REV.
B

AS3150™

BOLT, MACHINE - DOUBLE HEXAGON EXTENDED WASHER HEAD, CLOSE TOLERANCE SHANK, AMS4967 (UNS R56400), 160 KSI .3750-24 UNJF-3A

FIGURE 1 - BOLT

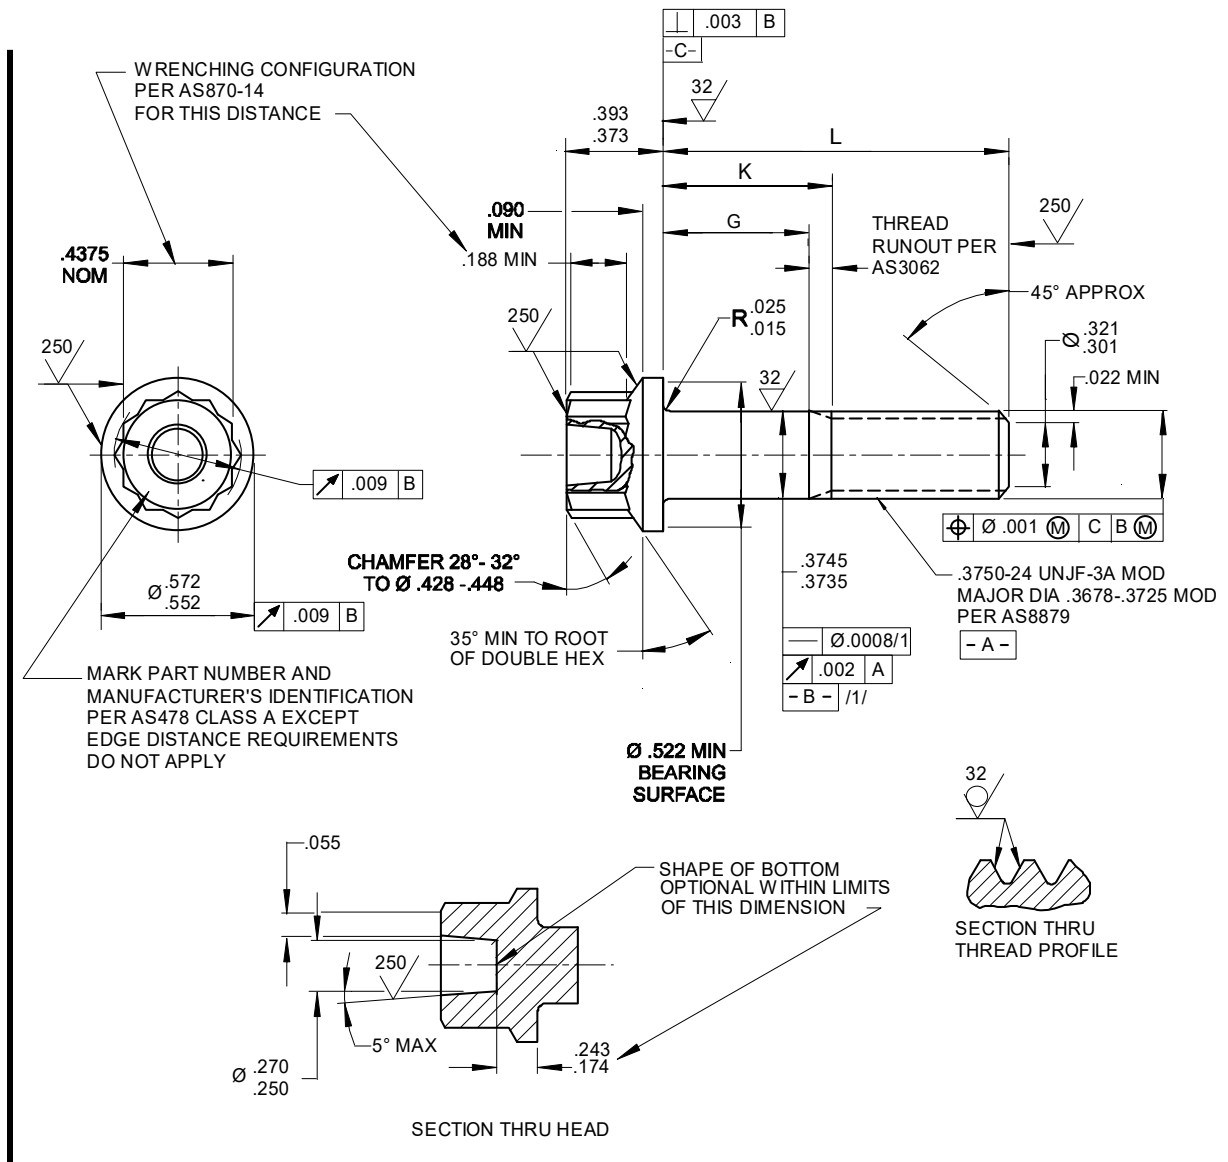
FIGURE REDRAWN TO SHOW CORRECT THREAD END CHAMFER AND LIGHTENING HOLE DIMENSIONS TO AS1132.
